**Planning Commission Meeting Agenda**

Tuesday, January 29, 2019, 5:30 PM

1. 319 N. French St. Remodel and Addition (CK) 319 N. French St., PL-2018-0367 10

1. Stephen C. West Ice Arena Additions and Alterations (CL) 189 Boreas Pass Road; PL-2018-0608 45

VIEW FROM  
FRENCH  
STREET

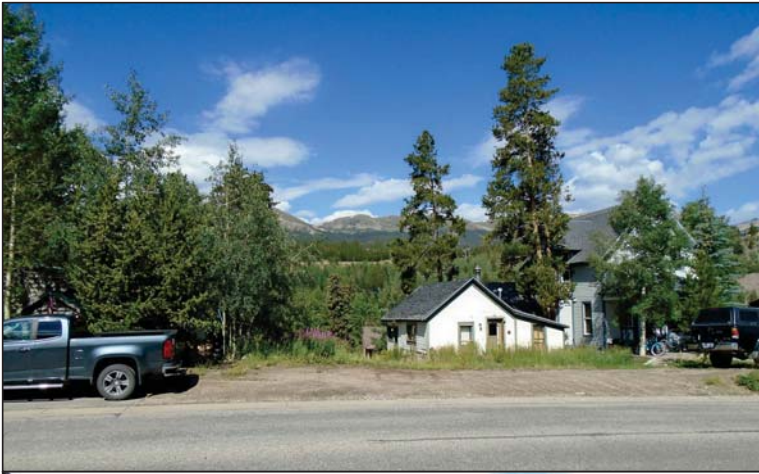
The plans show four, 14’ spruce trees and four, 10’ narrow leaf cottonwood trees in the front yard (North French). Further, the plan proposes a total of 27, 1.5”-2.5” aspen trees that are planted around the perimeter of the property which gives the plan a solid landscaping plan.

Based on past precedent, the landscape plan also exceeds the requirements of Policy 22/R and could earn positive 2 points under Policy 22/R if the caliper of the deciduous trees was increased to minimum of 2.5”. Does the Commission concur?

1 NORTH ELEVATION  
 1/4" = 1'-0"

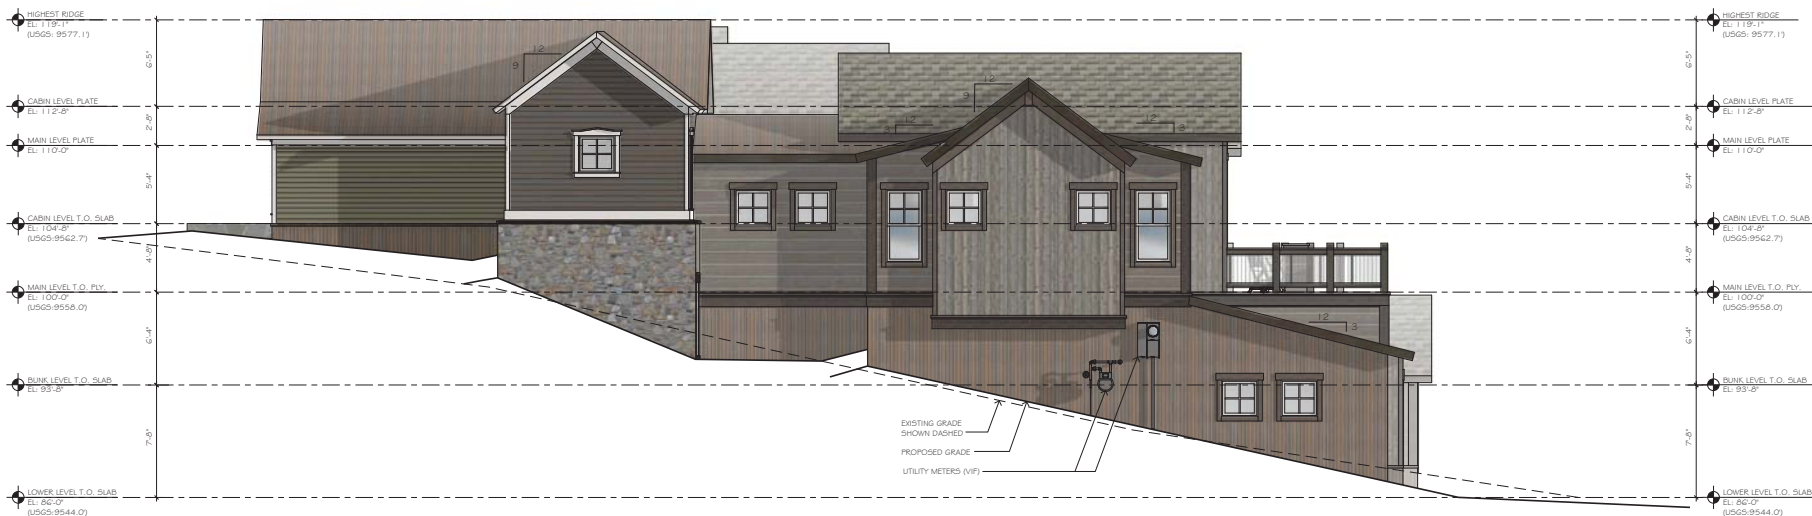
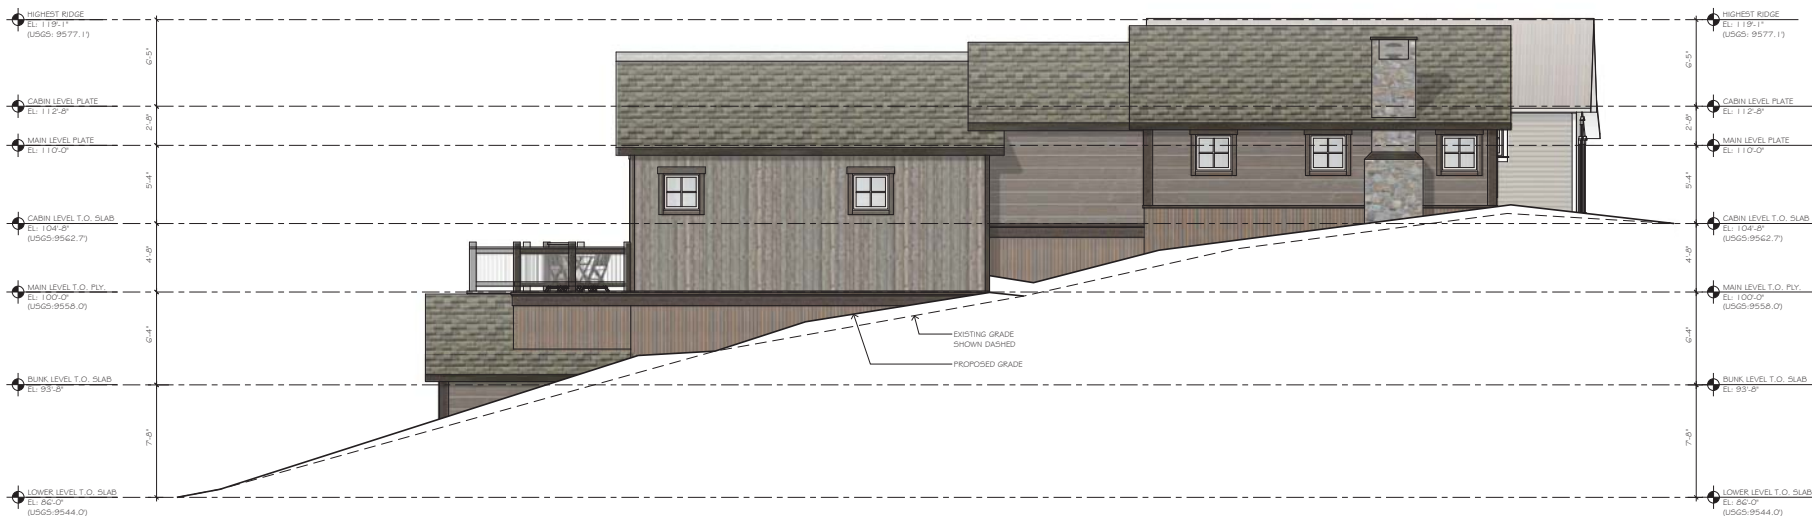
- (1) 2/3 light door has been removed.
- Triple hung windows on north elevation have been eliminated.
- The two large stone chimneys on the north and south elevations have been eliminated. The stone chimney on the east façade (front) has been revised and moved to the south façade.
- The siding and trim of the addition and connector has been revised to more rustic finishes.
- The width of the deck was reduced to 39' from 46.5'.
- Decorative corbels have been eliminated from the project.
- Porch has been eliminated from the southeastern addition.
- Stone has been significantly reduced except on the exposed foundation of the historic structure.
- Metal siding and wainscoting was switched to a pre-rusted finish.

**Ornament and Detail:** The elevations shows exposed ridge beams under the gables of the addition. Staff believes the use of exposed ridge beams on this project needs to be eliminated, to blend in with the modest character of the area. Design Standard 150 which suggests to *“Avoid elaborately ornate details that would confuse the genuine history of the area.”* Design Standard 93 further states to *“Avoid the use of non-functional or ornamental brick-a-brac that is out of character with the area.”* Based on these
